Staff Summary Report

SUBJECT: SOUTH MOUNTAIN COMMERCE CENTER

BRIEF: Request by City Council to appeal the Design Review Board decision on South Mountain Commerce Center for building elevation, site plan and landscape plan at 2420 West Baseline Road.

COMMENTS: **DESIGN REVIEW APPEALS (0102-05-03)** Request by City Council to appeal the Design Review Board decision on **SOUTH MOUNTAIN COMMERCE CENTER #DRB01011** (Michael Freret, Orsett Southwest, Ltd., Property owner) for building elevation, site plan and landscape plan located at 2420 West Baseline Road.

NORTH ELEVATION

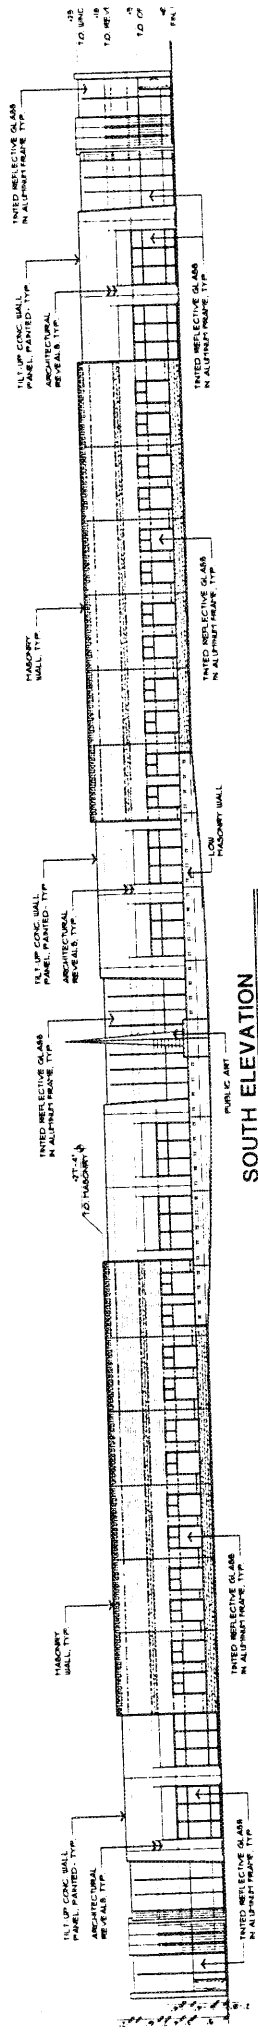
Although the applicant has added brick veneer to the south elevation and near the building entrance, a majority of the other elevations are painted tilt-up panels (a material commonly used for industrial buildings). We believe the brick accents should be incorporated to a greater extent on all four sides of the building. Staff believes the brick will add richness to the elevations and create the architectural upgrade as envisioned for an office building. In addition, more architectural elements should be provided to the strip windows such as awnings, or window sills, or a recess of the strip windows for greater articulation and movement.

There have been concerns expressed by the neighbors to north, that the building is too massive at the street and will hinder their view of South Mountain. The applicant has attempted to provide relief to the approximately 500 feet long building with offsets that range in depth from 8 feet to 40 feet, in sections that are 120 feet wide. We believe the building design should be modified to create two building elements or at least the impression that there are two buildings. We recommend that the middle 120 feet section be redesigned to separate the buildings and provide a courtyard between the buildings. This redesign should reduce the visual impact of the project along Baseline Road and mitigate some of the neighbors concerns for potential loss of views.

20. ~~Provide more articulation on the building such as adding awnings, window sills, and/or recessing the strip windows to soften the industrial appearance of the building. Details to be approved by Staff prior to the issuance of building permits.~~ **Should the City Council reinstate conditions #19 or #20, these items shall be returned to the Design Review Board as post-session items. (Modified by the Board)**
